Our Ref: 20623/P
 Doc Name: Sunbury South ICP Submission
 njh

**Amendment C243hume to the Hume Planning Scheme
 Submission on behalf of Asia-Pacific Property P/L**

Plan 5b

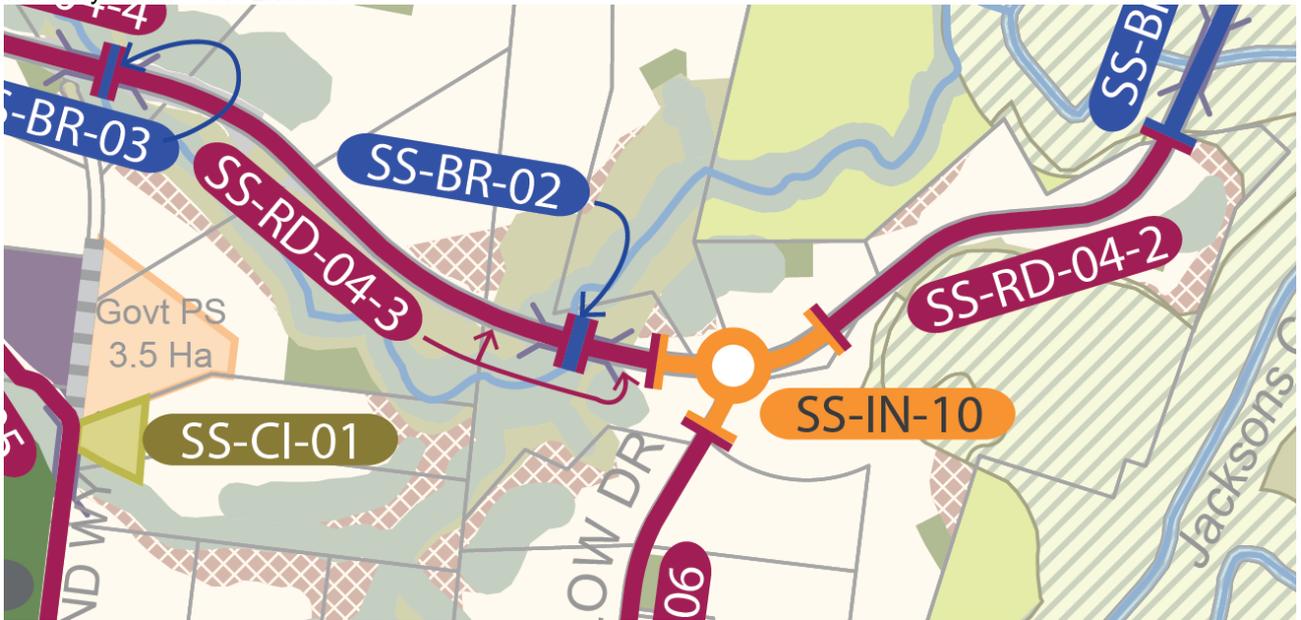
We do note what appears to be errors in Plan 5b of the exhibited ICP:

- SS-RD-04-3: land for the construction of this road should be extended to match the plans in the PSP and Plan 2b in the ICP
- SS-IN-10: the southern leg, in so far as it relates to road widening of Fox Hollow Drive, should be added to Plan 5b. This would then match the words on page 33 of the ICP which includes the *land for the ultimate configuration 3 way intersection*
- SS-RD-06: the road widening of Fox Hollow Drive should be noted on the plan, as per the words on page 32 of the ICP.
